MODIFIED FRONT BRAKE FORKS

R-R Silver Dawn, Silver Wraith, Bentley MKVI, R type

N. W. Geeson

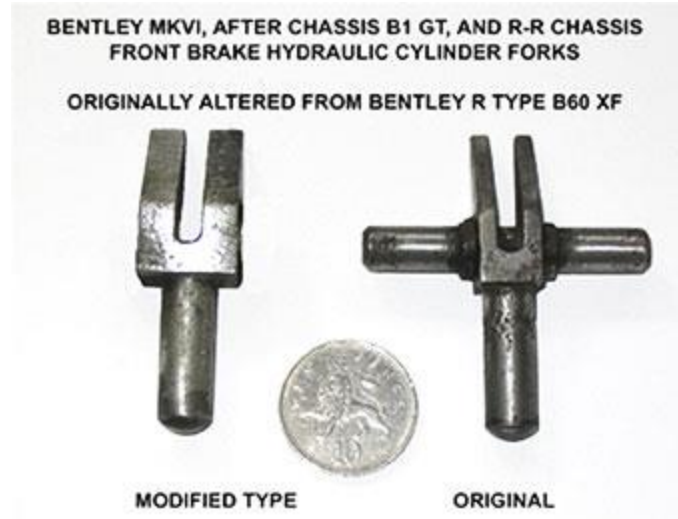
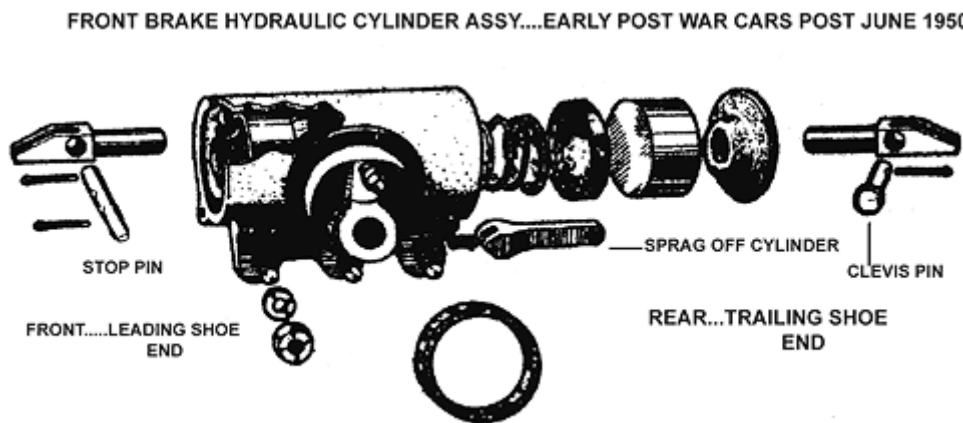
These forks were standardised on very late R types after chassis B 60 XF, and were intended to be retrofitted to Bentley MKVI after chassis B1 GT. Especially when more front end braking is demanded it is wise to fit them. Unfortunately it is not well known that these forks should be fitted, along with a different stop pin and clevis pins. One of these pins, the clevis I believe, is not available but can be obtained commercially.

- Modified fork part number RG 8490
- Modified Stop pin RG 8489
- Modified Clevis Pin K 4561/Z
